# PRODUCT CHANGE NOTIFICATION

## Bourns® Model SRN8040 Series Semi-shielded Power Inductors

### *Change to Inductor Core Design and Wire Diameter*

Existing Inductor Core Design

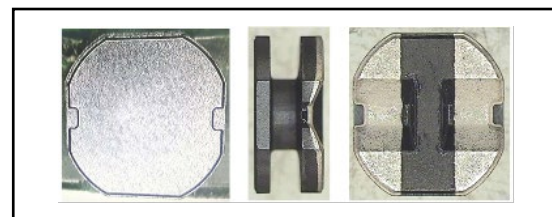
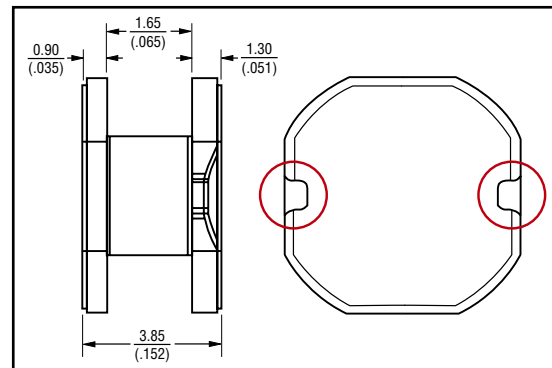
Riverside, California – August 13, 2021 – Effective February 12, 2022, Bourns will change the inductor core design of the [Model SRN8040 Series Semi-shielded Power Inductors](#). The modified inductor core will be comprised of a thicker top flange, removal of wire channels on the top flange and a reduced winding length. These modifications will strengthen the core structure and reduce the risk of a core crack.

In addition, for three of the above affected part numbers, the wire diameter will be reduced slightly to accommodate the reduced core winding length. Affected part numbers with this additional change are listed below.

The form of the inductor will be changed. The fit and function remain the same. The quality and reliability of the component should be improved as a result of the design change.
